## UPPER TRISHULI-1 HEP (216MW)

### REVIEW NOTE

<b>Title of the Document</b>	<b>Excavation and Initial Support Drawings of Adit No. 3</b>
------------------------------	--

<b>Review Note No.</b>	<b>RN-0054</b>	<b>Present Review Date</b>	<b>04.02.2022</b>
		<b>Present Review Status</b>	<b>AN</b>

**Drawing UT1-C-150-CVL-DG-43004-05, Rev. 0**

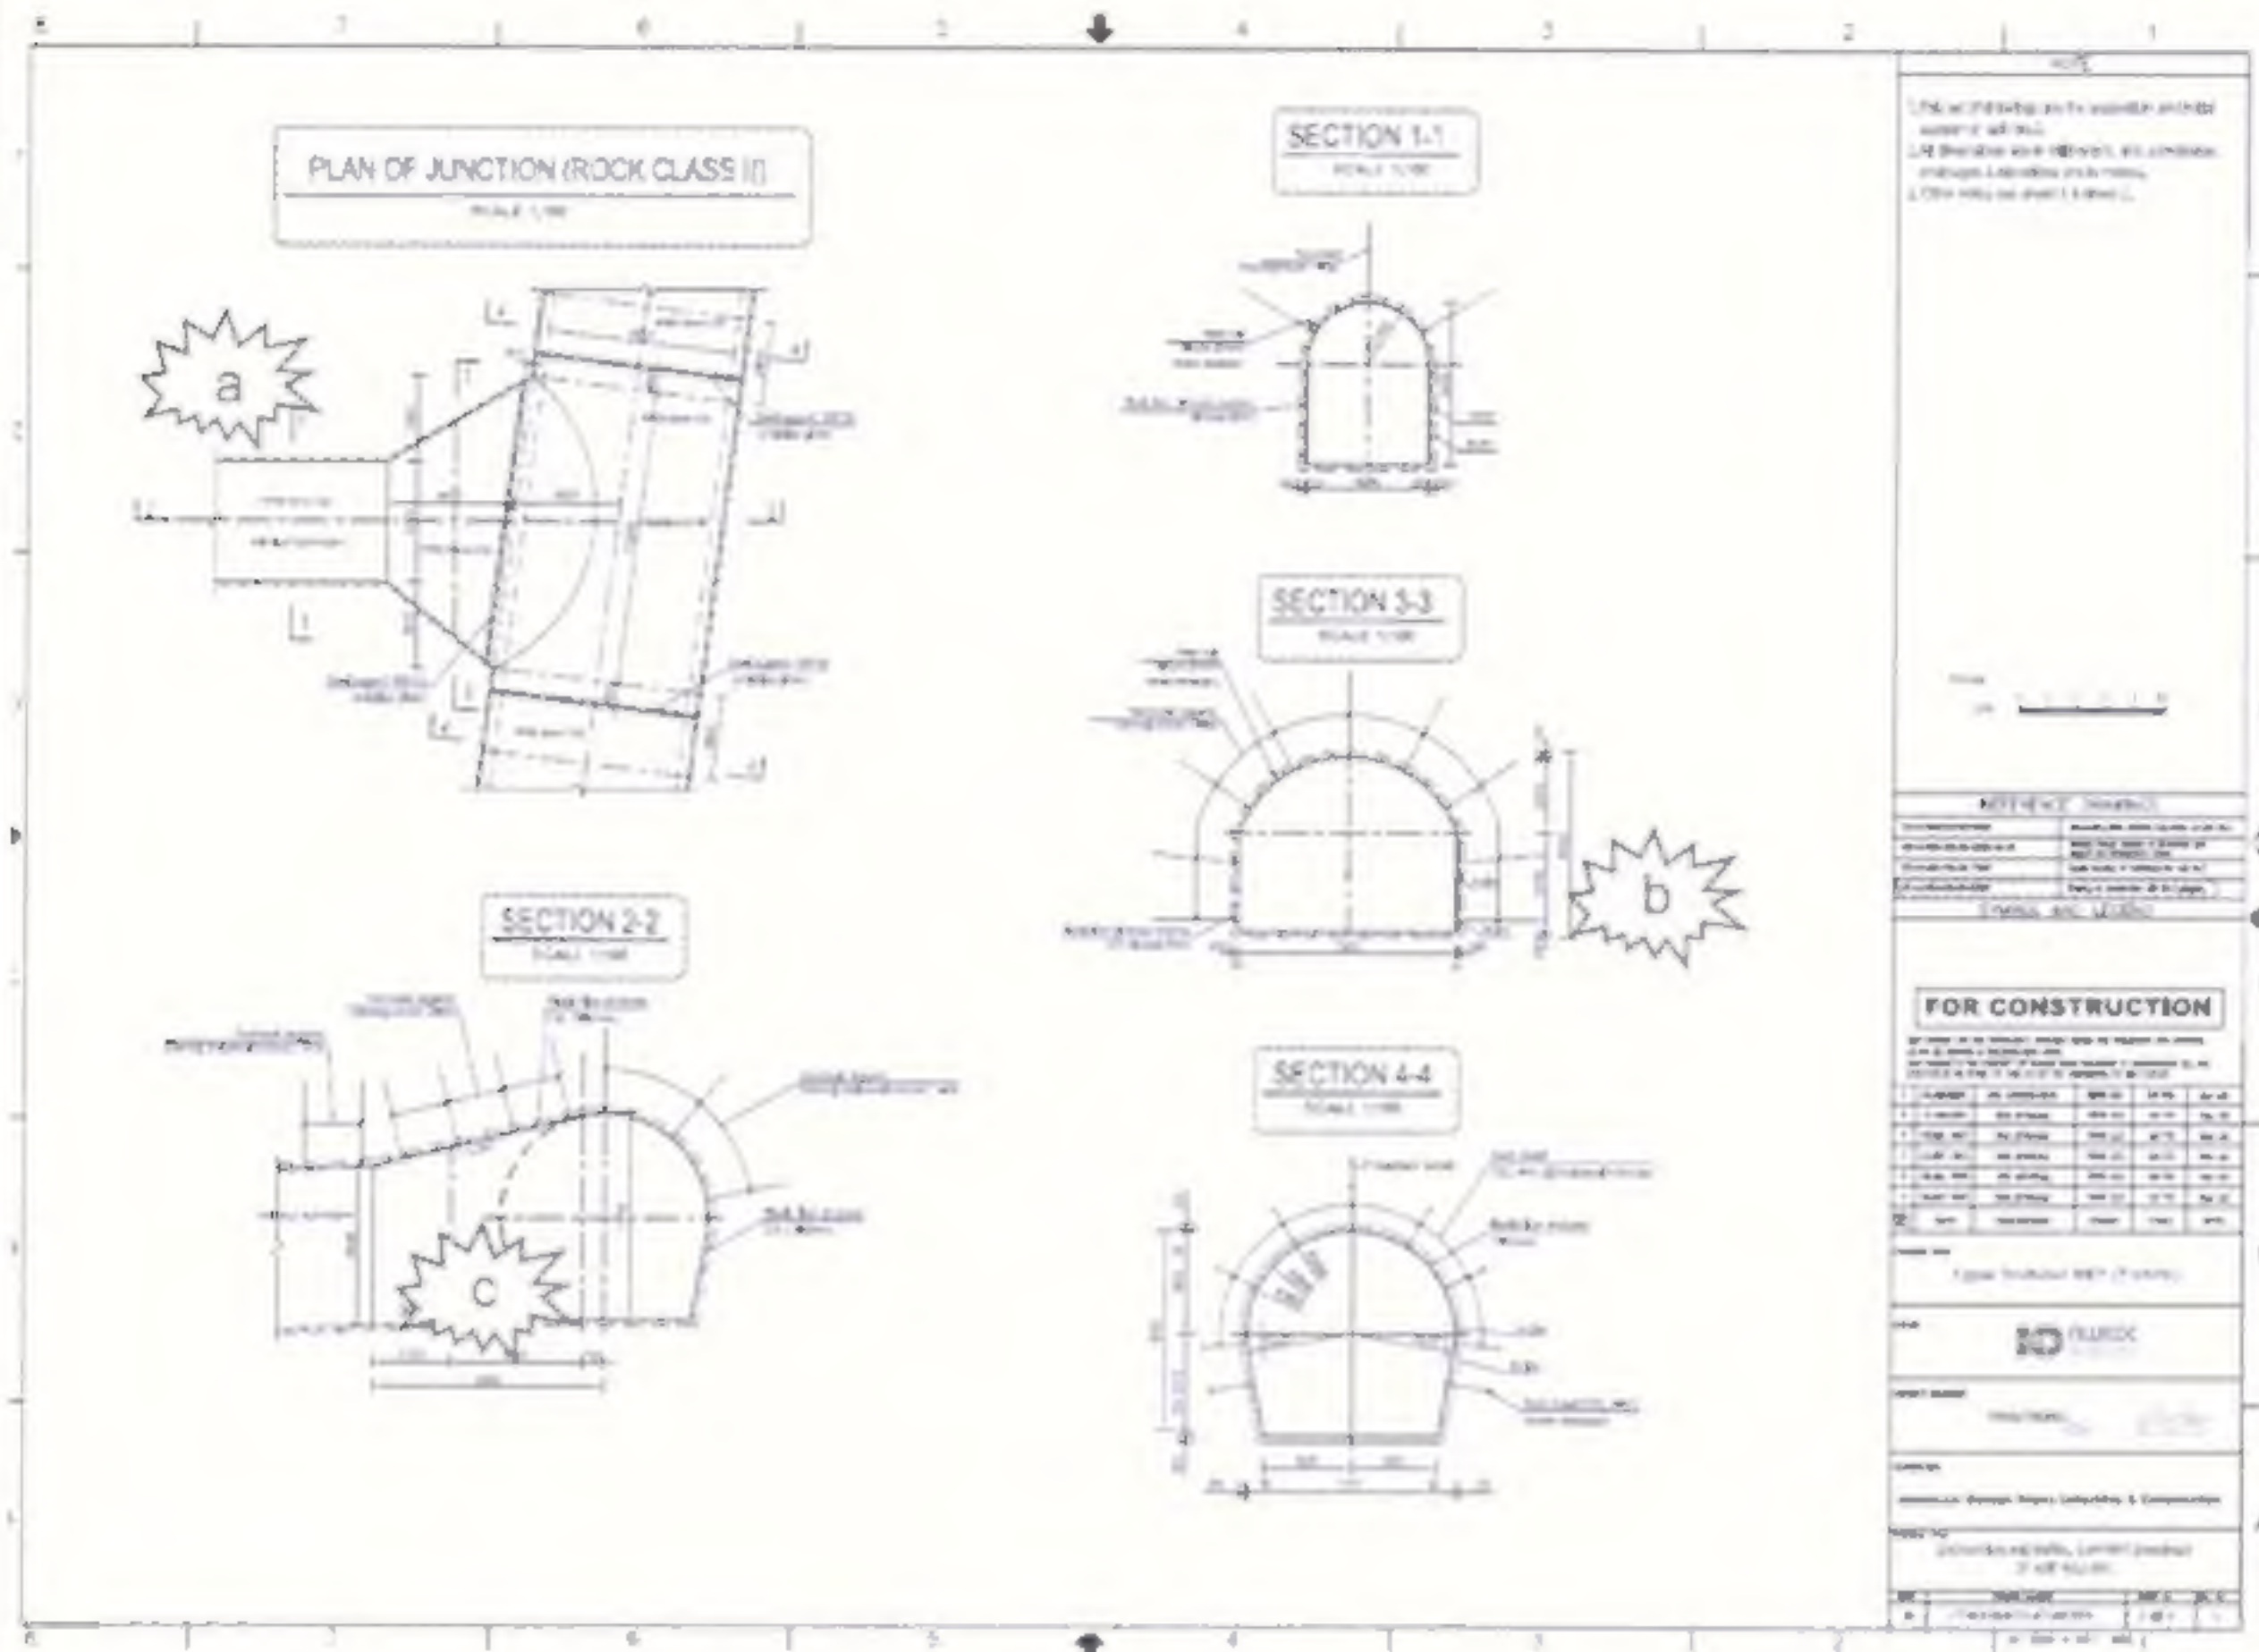
- a) The junction of the adit and the Headrace Tunnel should be orthogonal ( $=90^\circ$ ), otherwise shuttering for concreting will be very difficult. This requires a change in alignment of the adit shortly before the plug. Redesign.
- b) No dowels in sidewalls close to the tunnel invert required.
- c) Indicate concrete plug.
